From: White, Louise
Sent: 17 December 2024 08:25
To: Development Control
Subject: FW: The Central Hotel, 70 Main Street, Egremont
Attachments: Updated Windows.docx

From: Amanda Hyland
Sent: 12 December 2024 20:51
To: White, Louise
Subject: Re: The Central Hotel, 70 Main Street, Egremont

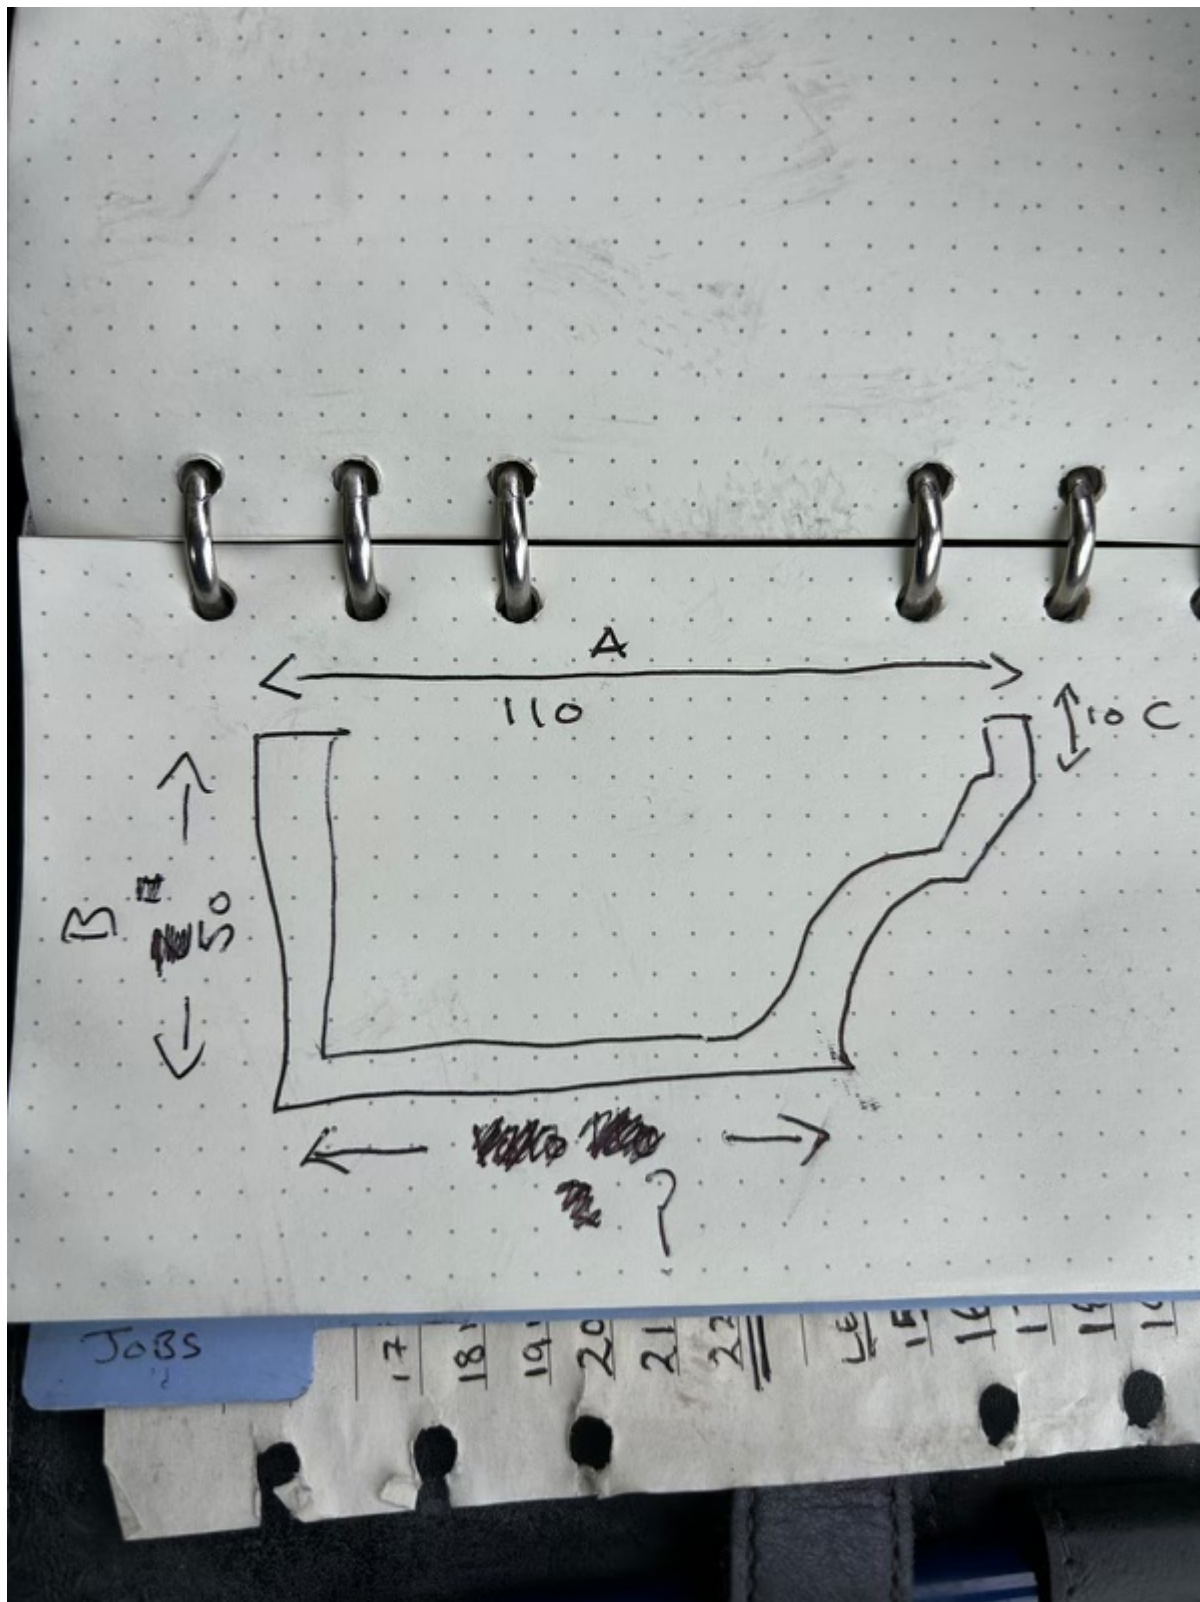
It is possible to amend the front window details please.
There maybe some funding for replacing the front windows in 2025, if this is the case I would like to access the funding and replace the front windows in a traditional wooden sliding sash.
I have said in the planning application that I will just be painting the existing windows, which will be correct, but I may wish to replace them so would like to have this permission in place so I am ready to access funding if it becomes available.

Please find attached the wooden window spec, these will be identical to the ones on the neighbouring property, 70a Main Street, which planning was granted for in Aug 2024.

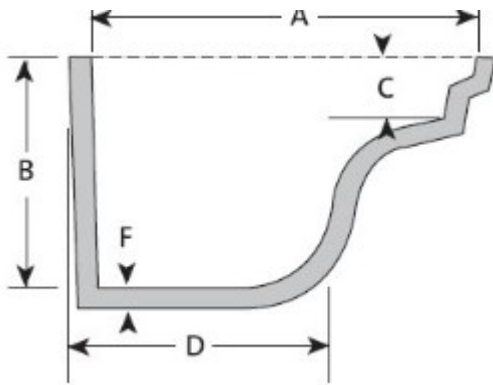
I can't see that the proposed design of the guttering would be problem. Are they able to provide the dimensions as shown A – F, or the brochure this came from please?

Regarding the guttering, is OGee black cast iron OK? Not half round as stated previously. The reason for this is the neighbouring/adjoining property has OGee on and I think it would look better

if this was continued across the face of the buildings, giving a more uniform look. The roofers have just given me this information.

Picture below.
